Reference is made to KC #353 and to the supplement questions KC#453 submitted to IACS on 20 April 2007.

Figure 1 Shear force capacity according to [5.1.2]

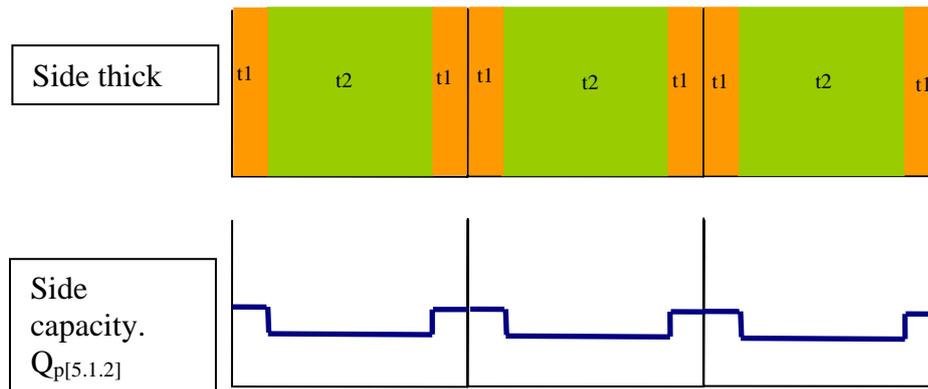
1. Shear force capacity curve.
 Q_p according to [5.1.2] are drawn up based on direct shear force calculation as given in [2.2.1]. Shear force capacity to be established based on direct calculation meaning shear flow analysis. See figure 1. Please confirm.

Figure 2 Strength check according to [2.2.2] and [5.1.2]

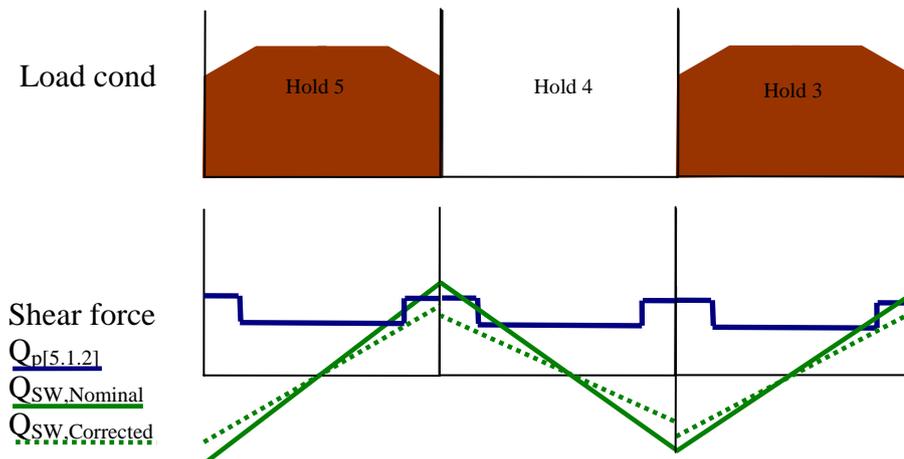
2. Approval verification.
 Design loading conditions in the loading manual should be plotted with both corrected and uncorrected shear force. Corrected shear forces are compared against Q_p according to Ch.5 Sec.1 [5.1.2]. The correction is performed according to [2.2.2] and performed for uneven loading conditions only. See figure 2. Please confirm.

Figure 3 Shear force approach according to [5.1.3]

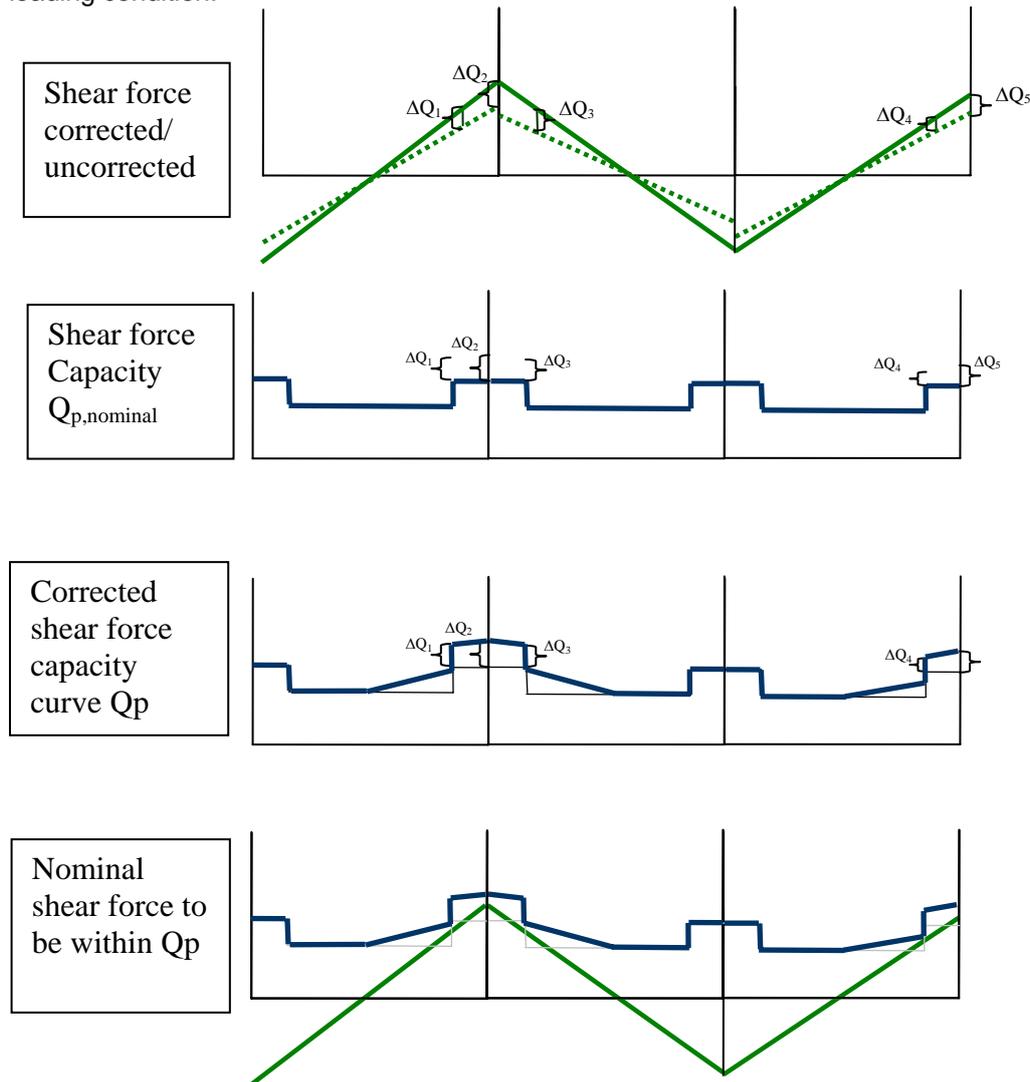
Q_p given in [5.1.3] includes shear force correction ΔQ_c which is absolutely “added” on top of the capacity limit based on the given scantlings and allowable stress. We suppose the intention of Q_p as given in [5.1.3] is to make shear force correction unnecessary in each loading condition calculated by the Loading Computer onboard. Please refer to figure 3 where the correction is made for one alternate loading condition.

This has created some confusion and uncertainty of Q_p as defined by [5.1.3] such as:

- 1) Uncertainty of shear force correction ΔQ_c included in Q_p when applied to a new loading condition calculated by Loading Computer onboard.
- 2) A few sets of Q_p need to be established to deal with different uneven loading conditions correctly.
- 3) In case of flooding conditions, the above two issues 1) and 2) will be more confusing and difficult to deal with.

To avoid any confusion and uncertainty, we therefore propose to take out Delta-Qc term from the Qp formula given in [5.1.3] and instead add texts in both [5.1.2] and [5.1.3] to the effect; “shear force correction as given in [2.2.2] should be applied to uneven loading conditions calculated by Loading Computer onboard. Corrected shear forces are then compared against Qp.” Same applies to Qpf formula in [5.3.3]. Please consider.
